TITLE: AIR CONDITIONING - AIR COOLING SYSTEM - INTRODUCE A MODIFIED RAM-AIR

MODIFICATION No.: 25459K4419

This page transmits Revision No. 01 of Service Bulletin No. A320-21-1098.

6 DATE : Aug 20/96 SERVICE BULLETIN No. : A320 - 21 - 1098

Modification of PERMA THREAD Tool Figure 1 Sheet 1

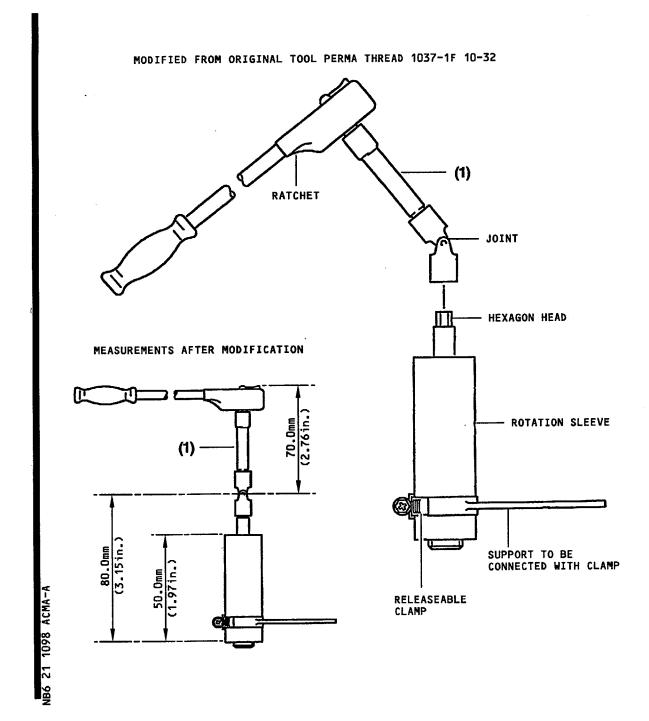
NOTE: The tool PERMA THREAD 1037-1F 10-32 has to be modified by the operator in accordance with the dimensions shown in Figure 1 of this Service Bulletin.

- (h) Put blanking caps on open duct ends.
- (i) Put blanking caps on disconnected line ends.
- (j) For threaded insert installation modify the tool PERMA THREAD 1037-1F 10-32, item (1), with the dimensions as shown in Figure 1, or the tool BOELHOFF HC UNF 10-32 (PN 0150 0169 700) in accordance with the dimensions shown in Figure 2, of this Service Bulletin.

Modification of the Boellhoff Tool Figure 2 Sheet 1

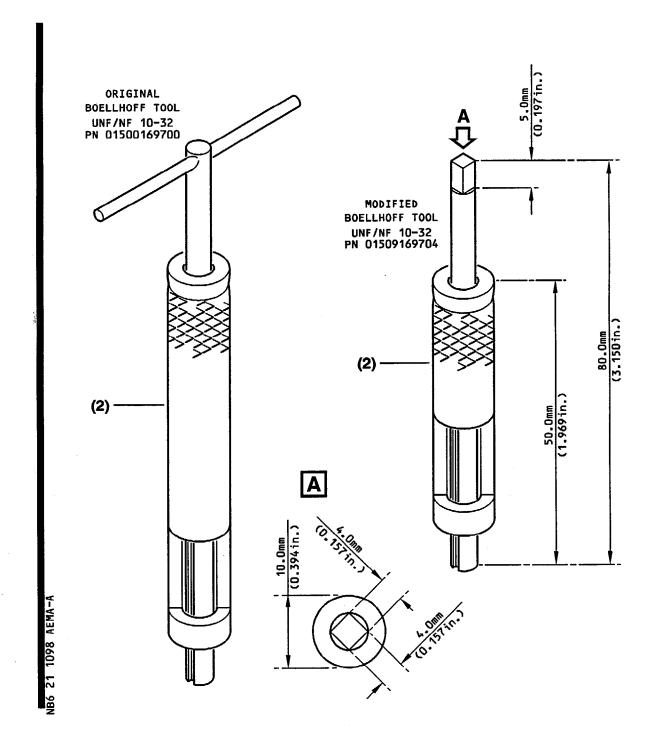
NOTE: The tool BOELLHOFF HC UNF 10-32 PN 0150 0169 700 has to be modified by the operator in accordance with the dimensions shown in Figure 2 of this Service Bulletin.
